# Fire Risk Assessment

For Centre Point

## Centre Point, Avondale Square Estate, London, SE1 5NS

ASSESSMENT REF. RB-MEW8HW

REFERENCE RB-CH92HR DUE 12/09/2025  
LOCATION Site-wide  
CATEGORY City of London: Inspection & Maintenance

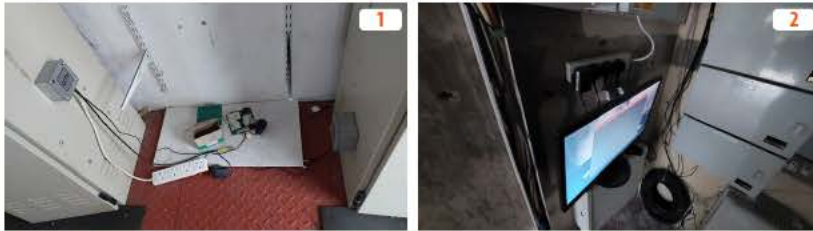
Confirm that a fixed wiring test has been undertaken in the last 5 years and that the system was certified as being in a 'Satisfactory' condition. If the fixed wiring was found to be 'Unsatisfactory', the necessary remedial actions should be undertaken so that the system is maintained in a 'Satisfactory' condition.

No evidence was seen to confirm if the status of the system is rated as 'Satisfactory'.

REFERENCE RB-LQ8U19 DUE 12/09/2025

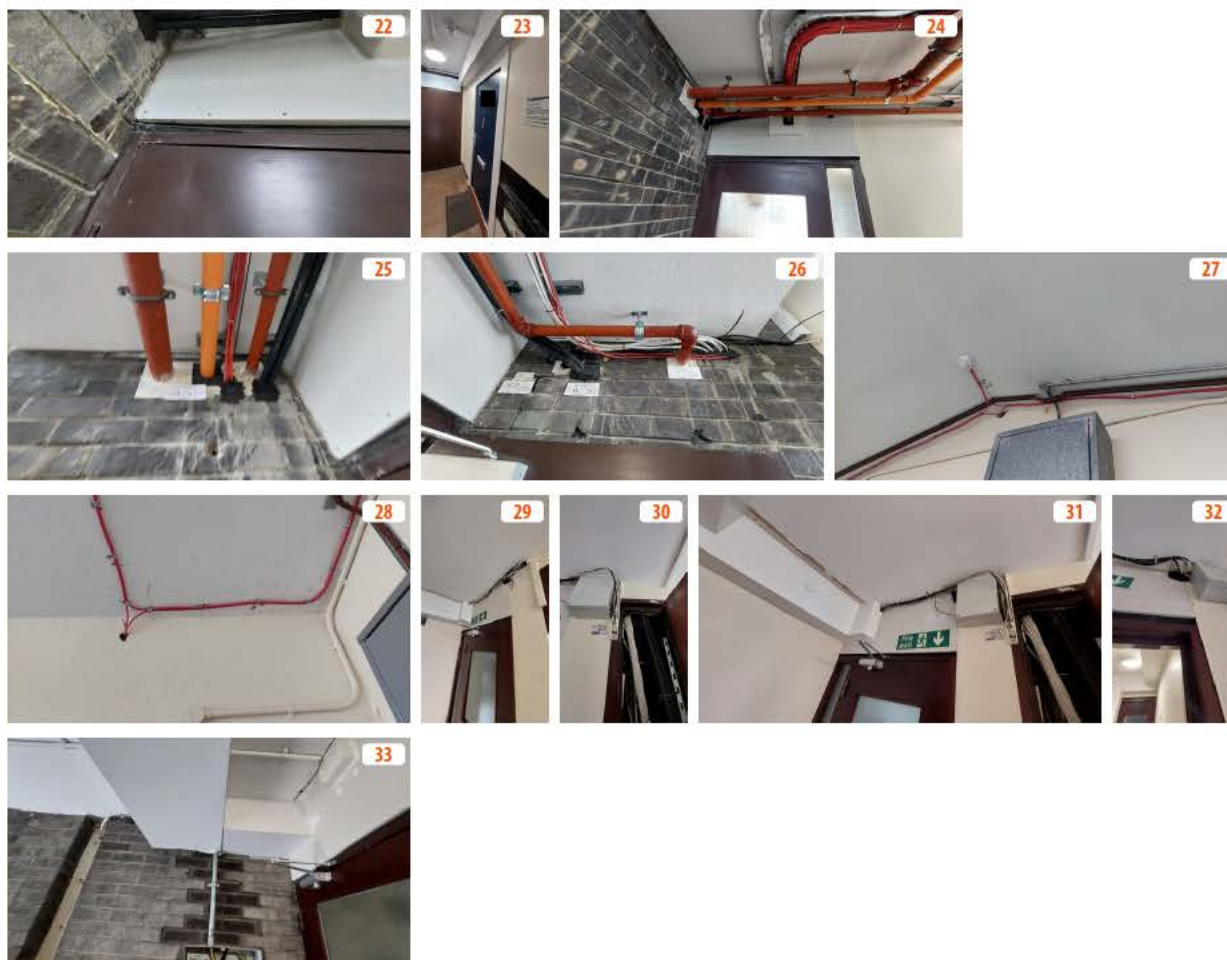
A sprinkler system and fire detection system have recently been installed within the premises. During the assessment, it was noted that the sprinkler pipework and detection cables penetrate through multiple compartment walls and ceilings, with either no fire-stopping in place, or poorly installed fire-stopping in several areas. These deficiencies may significantly compromise the integrity of the compartmentation, which is intended to provide 60 minutes of fire resistance. Some areas of the installation are boxed in, so it was not possible to inspect them.

Ensure a competent passive fire protection specialist reviews all areas where new sprinkler and fire alarm services are breaching compartment walls to identify unsealed or poorly sealed service penetrations. Where found necessary, remedial fire stopping works should be undertaken to ensure the compartments provide a minimum of 60 minutes fire resistance.

REFERENCE RB-7QLUPC DUE 15/11/2025

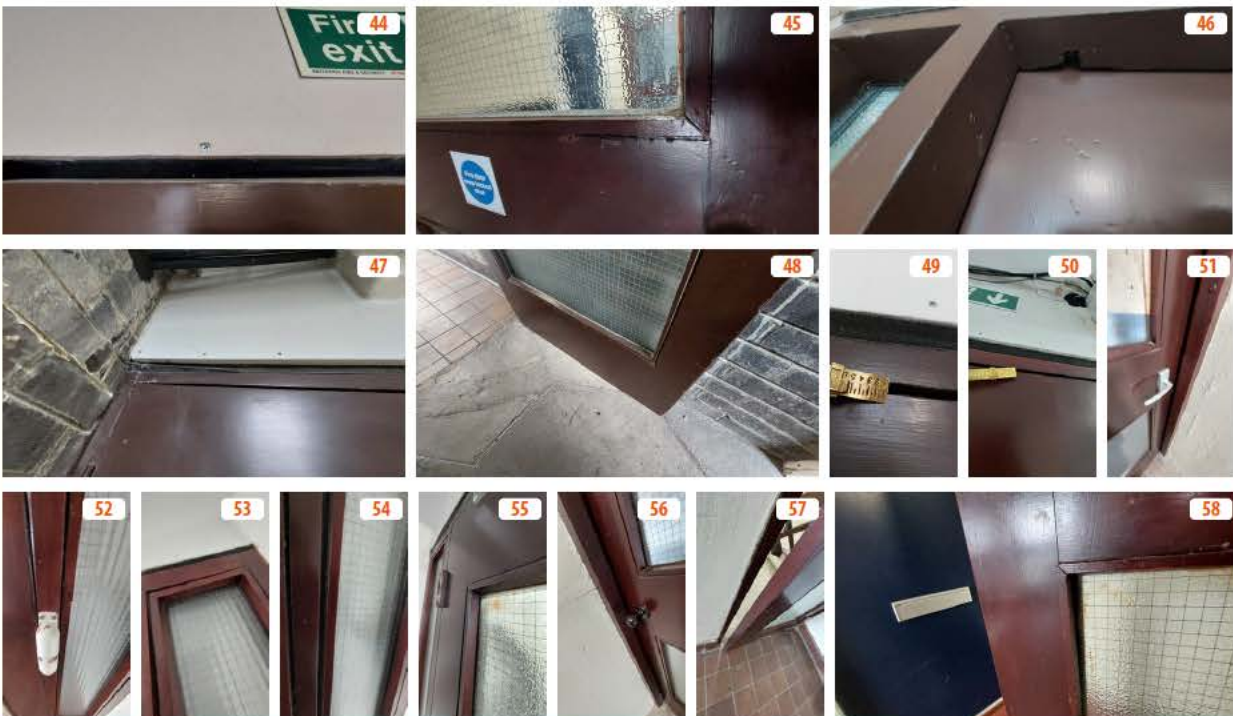
A significant number of communal fire doors, particularly those located between the flats and the internal staircase, were found to have multiple defects. Issues included loose glazing, loose beading around glazing, doors not sitting flush within the frame, failure to latch properly, self-closing devices causing doors to slam, doors self-wedging to the ground and excessive gaps around the door edges. These deficiencies undermine the ability of the doors to provide effective fire and smoke resistance along the means of escape.

Ensure a competent passive fire protection specialist reviews all communal fire doors, particularly those serving the internal staircase and flat entrances, to assess their condition. Where necessary, remedial works should be undertaken to ensure the doors are in a maintained, fully functional condition, capable of providing a minimum of 30 minutes fire resistance.
